TO: Planning & Zoning Commission

FROM: Sonya Allen, Associate Planner
208-884-5533

SUBJECT: Burnside Ridge Estates – AZ, PP
[H-2023-0055](#)

Annexation of 123.28 acres of land with R-2 (11.91 acres), R-4 (89.55 acres) and R-8 (21.82 acres) zoning districts; and preliminary plat consisting of 263 building lots, 33 common lots and one (1) other lot, which is a holding area for future re-subdivision, on 121.31 acres of land in the R-2, R-4 and R-8 zoning district.

B. Preliminary Plat & Phasing Plan (dated: 2/29/24)

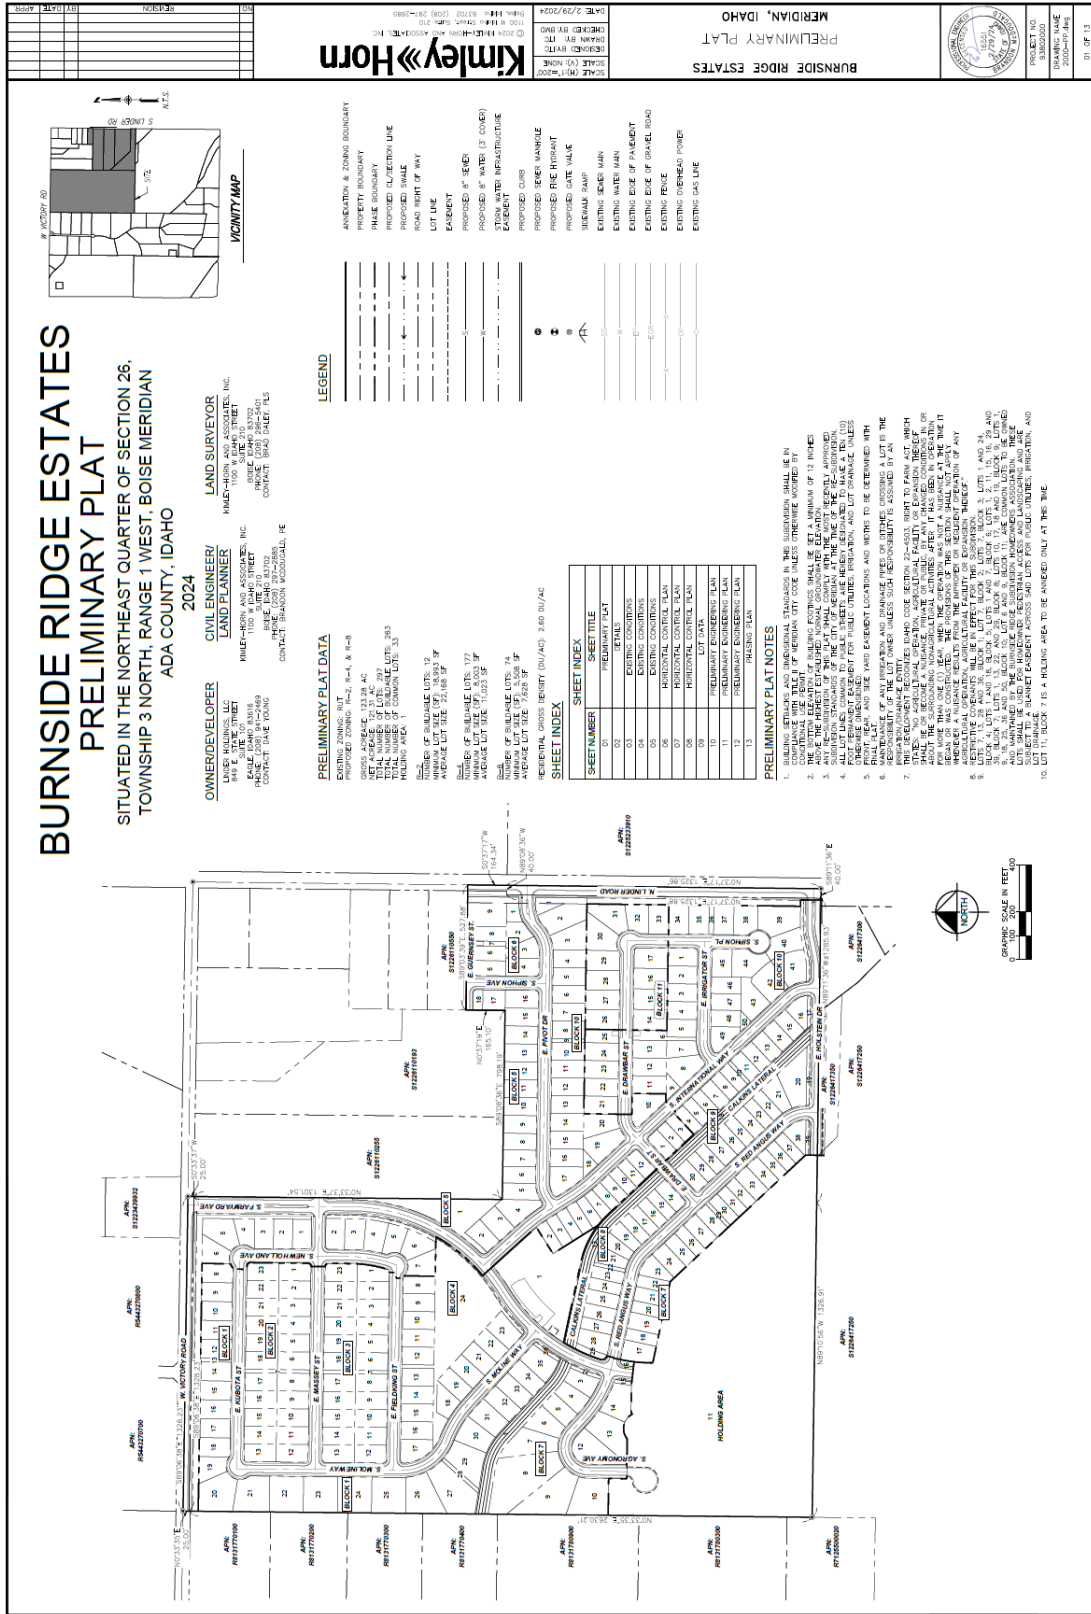
The following block faces exceed the maximum length allowed in UDC [11-6C-3F](#): Block 7 (south side of S. Red Angus Way), Block 1 (west side of S. Moline Way), Block 5 (north side of E. Pivot Dr.) and Block 10 (south side of E. Pivot Dr.). Staff recommends the plat is revised to comply with the maximum block face standards and/or a request for City Council waiver(s) to the standards is submitted prior to the City Council hearing. *Note: Block face is measured from the near edge of right-of-way to near edge of right-of-way of streets per UDC 11-6C-3F.5.*

An open space exhibit was submitted as shown in Section VIII.D that depicts common open space totaling 11.53-acres (or 502,242 s.f.), **which is 1.06-acres (or 46,174 s.f.) below the required amount and includes areas that don't meet the qualifications for such in UDC 11-3G-3B. Areas that don't qualify include the following: Lot 18, Block 10, Lot 9, Block 11 and Lot 7, Block 6 as they don't seem to have been integrated into the development as a priority and appear to be remnant areas; the common lots encompassed by the Calkins Lateral easement as the Boise Project Board of Control doesn't allow their easement to be landscaped (only gravel is allowed within their easement); and common lots for micro-paths that are below 20' in width. These areas should be removed from the qualified open space calculations. Parkways along local streets may be counted if they meet the standards listed in UDC 11-3G-3B.4. The common area outside of the Calkins Lateral where the pathway and associated landscaping is located can also be counted.**

Waterways: The Calkins Lateral crosses the southwest portion of this site within a 60' wide federal easement (30' each side from centerline) – **the plat currently depicts a 40' wide easement and should be revised to accurately reflect the width of the easement or approval should be obtained for a reduced easement.**

The Givens Lateral runs along the west boundary of the site; a 7' wide easement exists on this site, which will run along the rear of adjacent building lots – the lateral itself lies on the abutting property to the west. **Consent should be obtained from the New York Irrigation District for the 7' wide easement to be located on adjacent building lots and perimeter fencing to be installed on the property line within the easement; otherwise, the easement should be placed in a minimum 20-foot wide common lot, which could be counted toward the qualified open space requirement if landscaped in accord with the standards in UDC 11-3G-5B.**

- e. The following blocks exceed the maximum block face length allowed in UDC [11-6C-3F](#): Block 7 (south side of S. Red Angus Way), Block 1 (west side of S. Moline Way), Block 5 (north side of E. Pivot Dr.) and Block 10 (south side of E. Pivot Dr.). ***The plat shall be revised to comply with the maximum block face standards prior to the City Council hearing and/or a request for City Council waiver(s) to the standards shall be submitted.***

- j. Depict root barriers where 6-foot wide parkways with Class II trees are proposed per the standards listed in UDC [11-3A-17E.2](#).
3. The landscape plan submitted with the final plat shall include the following revisions:

- a. Include all revisions to the plat noted above in #A.2, as applicable.
 - b. No landscaping other than gravel is allowed within the Calkin's Lateral easement unless otherwise approved by the Boise Project Board of Control. *If landscaping is allowed, written confirmation of such is required to be submitted to the Planning Division.*

C. Landscape Plan & Tree Mitigation Plan

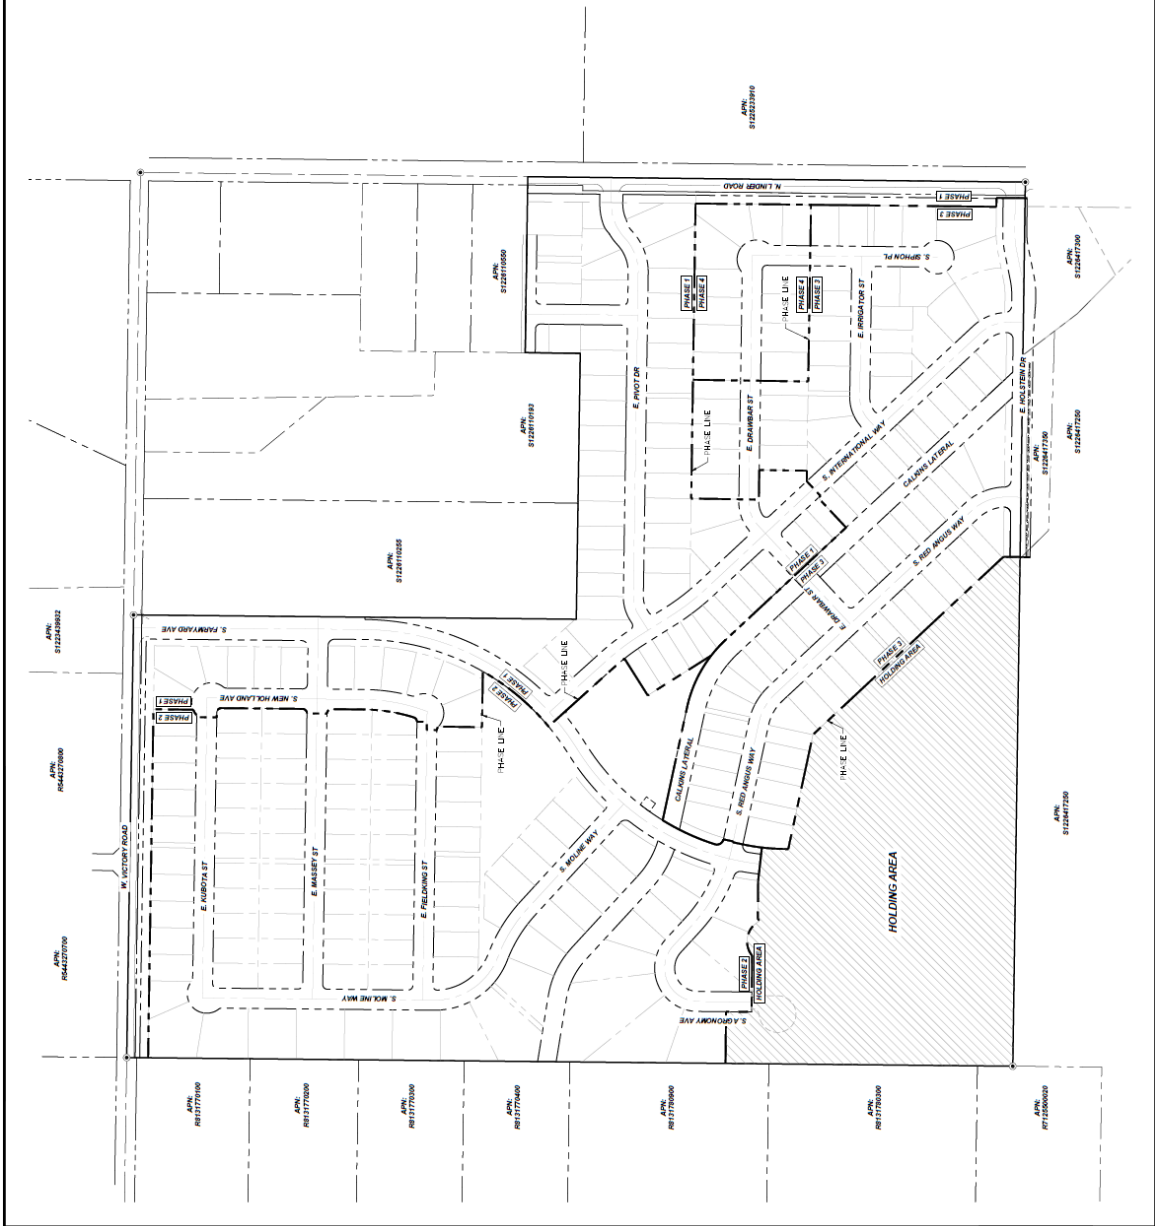
All common open space areas are required to include a minimum of one (1) deciduous shade tree for every 5,000 s.f. of area and include a variety of trees, shrubs, lawn, or other vegetative groundcover in accord with UDC [11-3G-5B.3](#). The landscape plan should depict landscaping accordingly and include calculations demonstrating compliance with the minimum standards.

There are several existing trees on the site that are proposed to be removed that require mitigation in accord with the standards listed in UDC [11-3B-10C.5](#). A mitigation plan was submitted, included in Section VIII.C, that depicts compliance with the aforementioned standards. A total of 313 caliper inches of trees are required for mitigation; a total of 314 caliper inches of replacement trees are proposed in accord with UDC standards.

Fencing: All fencing is required to comply with the standards listed in UDC [11-3A-6C](#) and [11-3A-7](#), as applicable. The landscape plan depicts privacy fencing adjacent to common open space lots and the perimeter boundary of the site but doesn't include a detail of the fencing type and height. **Fencing details should be depicted on the landscape plan submitted with the final plat application(s).**

- f. Include a fencing plan with details of the proposed fencing that demonstrate compliance with the standards listed in UDC [11-3A-6C](#) and [11-3A-7](#).

- g. Depict at least one (1) site amenity from the multi-modal category (see UDC [Table 11-3G-4](#) for more information).
 - h. Include a detail for the picnic areas, children's play structure (i.e. tot lot), public art, fitness course, sports courts, outdoor fire ring, commercial outdoor kitchen and multi-modal amenity that demonstrates compliance with the standards listed in UDC [11-3G-4C](#).

- i. All common open space areas are required to include a minimum of one (1) deciduous shade tree for every 5,000 s.f. of area and include a variety of trees, shrubs, lawn, or other vegetative groundcover in accord with UDC [11-3G-5B.3](#). The landscape plan shall depict landscaping accordingly and include calculations demonstrating compliance with the minimum standards.
